### **REMARKS/ARGUMENTS**

Appl. No.: 09/975,168  
Amdt. dated 12/08/2004  
Reply to Official Action of September 8, 2004

Amendments to the Drawings:

FIG. 1

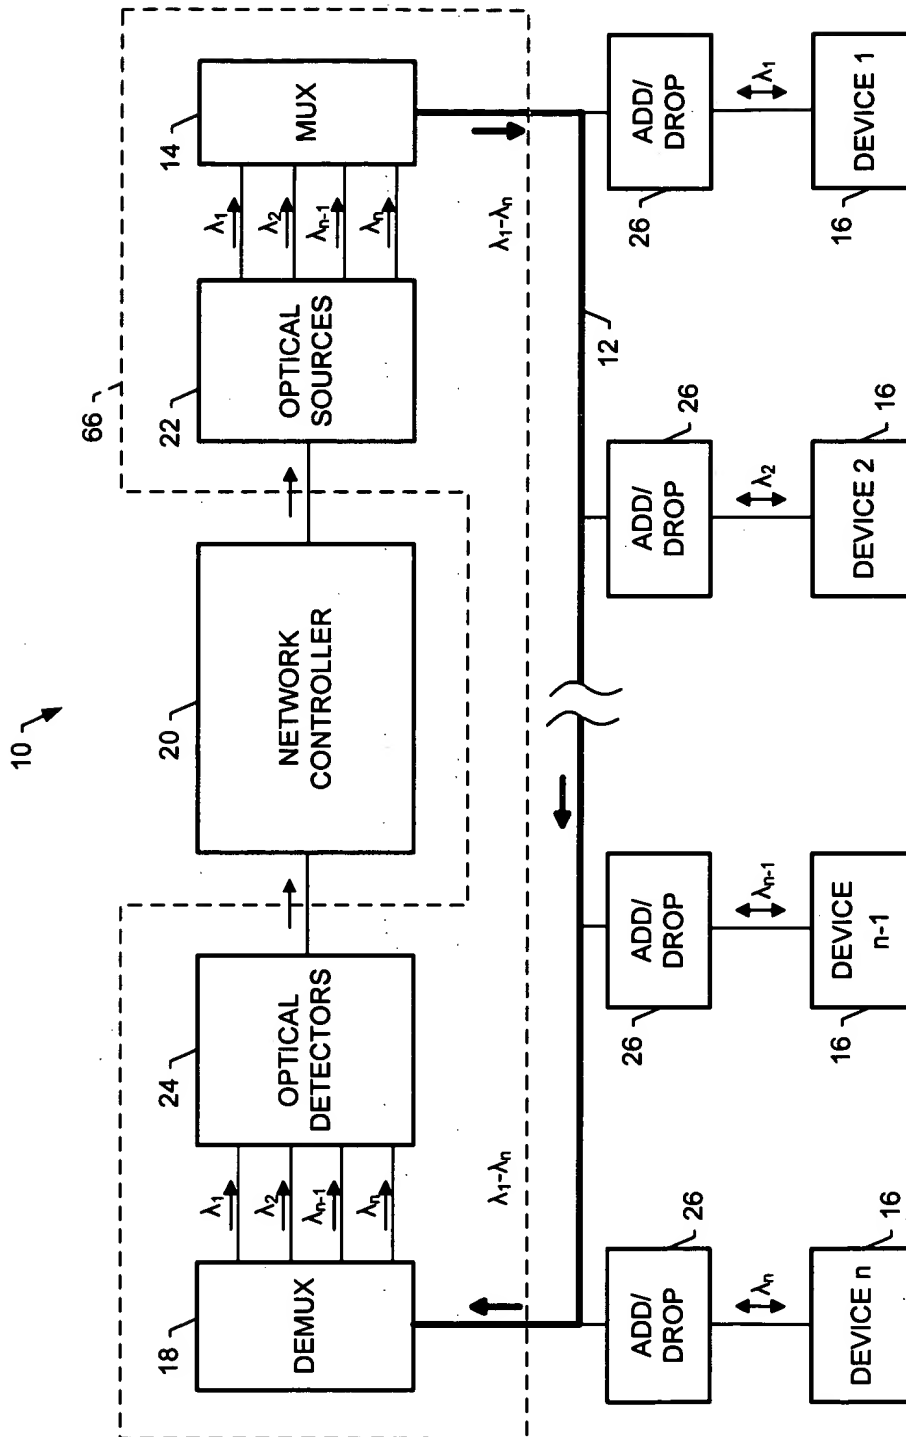
Applicants appreciate the thorough examination of the present application, as evidenced by the first Official Action. The Official Action objects to the drawings under 37 C.F.R. 1.83(a) for failing to show every feature of the invention. More particularly, the Official Action alleged that the drawings fail to show the transceiver, as recited in Claims 7-11. The Official Action also rejects Claims 1-20 under 35 U.S.C. § 103(a) as being unpatentable over U.S. Patent No. 5,717,795 to Sharma et al. In addition, the Official Action rejects Claims 21-26 under 35 U.S.C. § 103(a) as being unpatentable over the Sharma patent, in view of U.S. Patent No. 4,089,584 to Polczynski.

In response to the Official Action, Applicants have amended FIG. 1 to include transceiver 66. Accordingly, Applicants have also amended the specification of the present application to include the callout for the transceiver. Applicants note that as the transceiver added to FIG. 1 merely illustrates a combination of the elements (e.g., multiplexer 14, demultiplexer 18, optical sources 22, optical detectors 24) disclosed in the specification of the present application, no new matter has been added to the present application by virtue of the amendment to FIG. 1 or the accompanying amendment to the specification. Thus, Applicants respectfully submit that the objection to the drawings is overcome.

The enclosed sheets of formal drawings, which include FIGS. 1-3, replaces the original sheets including FIGS. 1-3. In view of the Official Action's objection to the drawings under 37 C.F.R. 1.83(a) as not showing every feature of the invention specified in the claims, in the attached replacement drawing sheet including FIG. 1, previously omitted transceiver 64 has been added. An annotated drawing sheet including FIG. 1 is also enclosed to illustrate the added transceiver.
